<b>LEXINGTON-FAYETTE URBAN COUNTY GOVERNMENT</b> <b>CONTRACT CHANGE ORDER</b> Page 1 of 2		Date:	July 28, 2025
		Project:	LFD Community Paramedicine Renovation
		Location:	117 Cisco Road Lexington, KY 40504
To (Contractor): BMI Builds, LLC 156 Rocky Waters Way Georgetown, KY 40324		Contract No.	073-2025
		Original Contract Amt.	\$186,888.00
		Cumulative Amount of Previous Change Orders	\$0.00
		Percent Change - Previous Change Orders	0.00%
		Total Contract Amount Prior to this Change Order	\$186,888.00
		Change Order No.	1
You are hereby requested to comply with the following changes from the contract plans and specification;			
<b>Current Change Order</b>

**JUSTIFICATION FOR CHANGE**

PROJECT: LFD Community Paramedicine Renovation

CHANGE ORDER #: 1

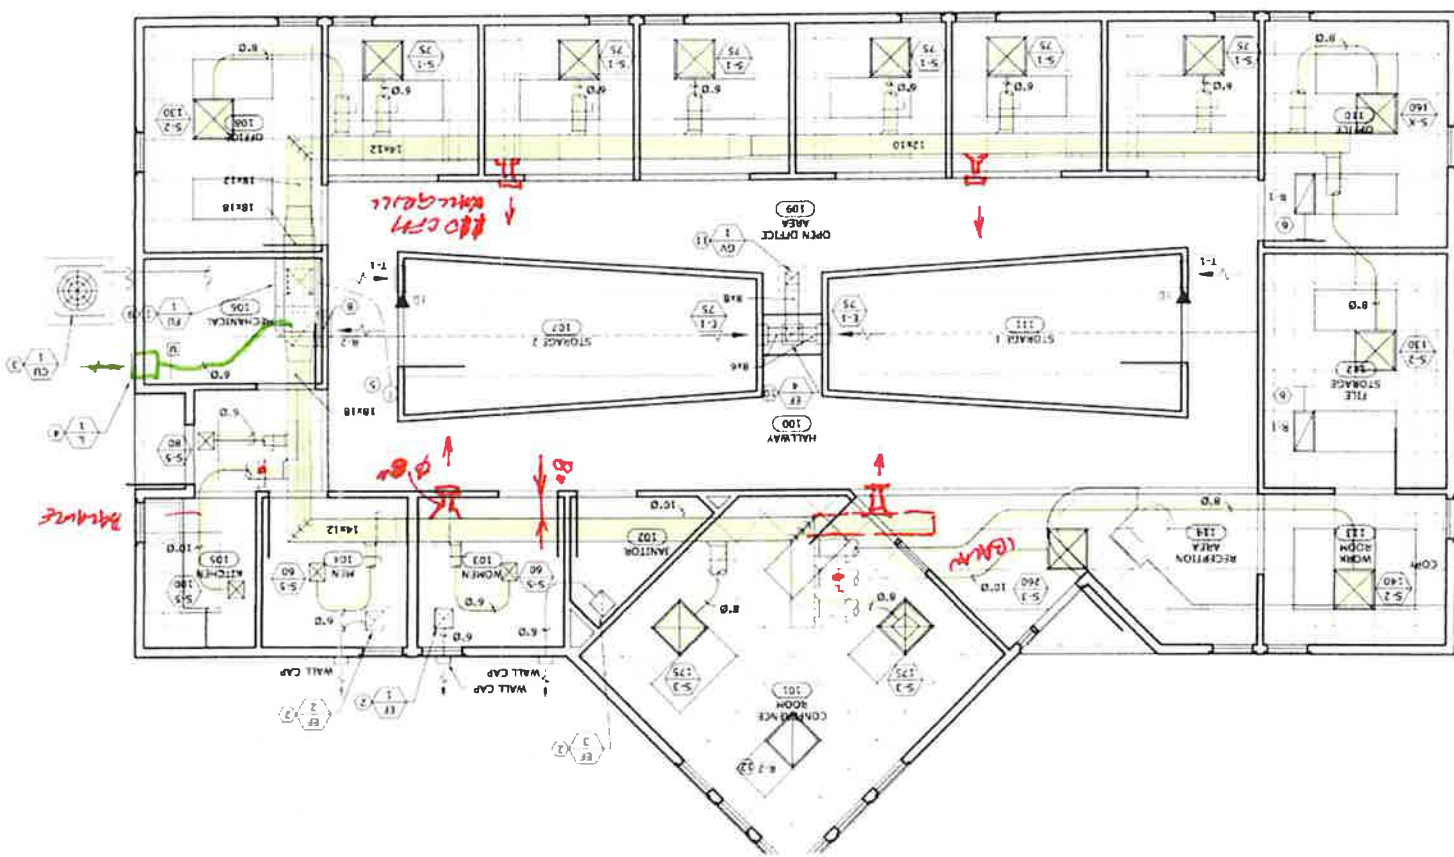
## **PR #2A: HVAC Air Distribution Modifications**

- A. Provide and install (4) additional side wall supply registers and associated ductwork in order to provide more conditioned air to the open office area. 110cfm per register.
- B. Centerline of new supply registers to align with centerline of existing linear wall mounted light fixtures.
- C. Provide and install (1) transfer grille between Open Office Area [109] and Women [103].
- D. Rebalance the existing duct system to accommodate the additional supply registers.
- E. Refer to attached sketch for duct modifications.
